ITEM #1 - PRELIMINARY PLAT US SURVEY 3564 REPLAT

KPB File No.	2024-141
Plat Committee Meeting:	February 12, 2024
Applicant / Owner:	Paul and Marcia Zimmerman of Kasilof
Surveyor:	James Hall / McLane Consulting LLC
General Location:	Kalifornsky Beach Rd and Sadie Lane in Kasilof

STAFF REPORT

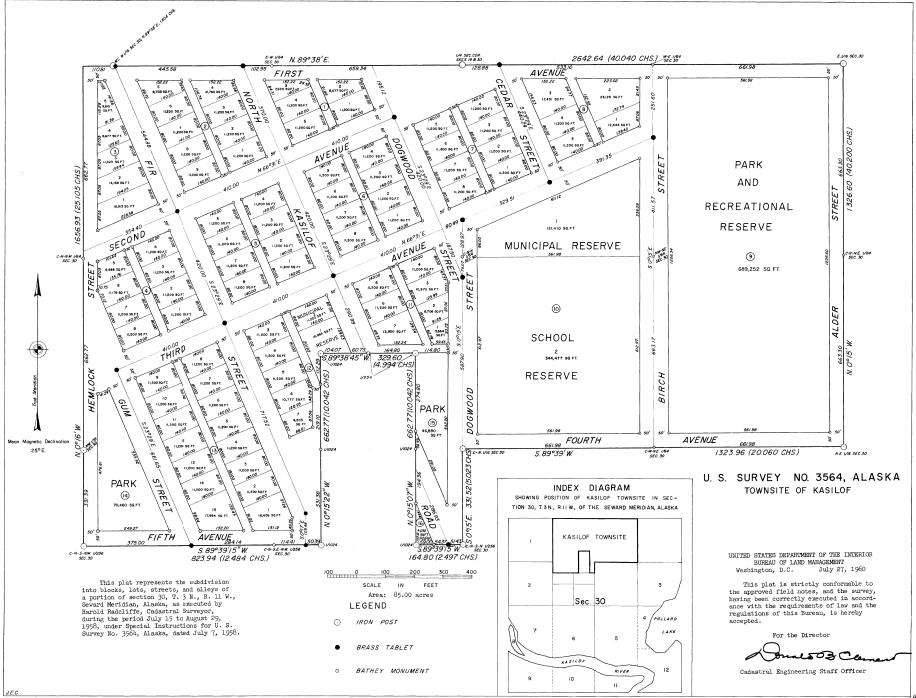
The 20' building setback line needs to be extended east across the alley on the south end of the lot.

Thee appears to be a possible encroachment on the south line near Lot 1 to line or building setbacks and utility easement. **Staff recommends:** the surveyor verify the location of the structure and either show the location to the lot line on the drawing or give a written report to staff.

No additional easements have been requested. The 10' utility easement needs to be extended across the alley right of way to the east.

Change the KPB File No to 2023-141 in title block Label 30' alley between Lot 1 and portion of new lot 2A on drawing

Adjust wording of Kalifornsky Beach Rd, Kalifornsky looks to be going up the section line

New lot number should be unique from previous, make it Lot 2A

Contours can be removed and shade the areas of steep grade on final

There looks to be an encroachment near the lot line with Lot 1 Block 11, surveyor should verify and give staff a report on the findings.

Record distance on west line is 246.66'

Easement listed in plat note 8.1 is located in lot 7 block 11 according to the description. Please modify appropriately.

- "No access to state maintained rights-of-way permitted unless approved by the State of Alaska Department of Transportation."
- Add a note concerning the approval of the vacation of the 30' alley by the Planning Committee on January 8, 2024 and he Assembly on January 16, 2024.
- The borough will not enforce private covenants, easements, or deed restrictions per KPB 20.60.170.

Add to the Plat Approval the date of February 12, 2024
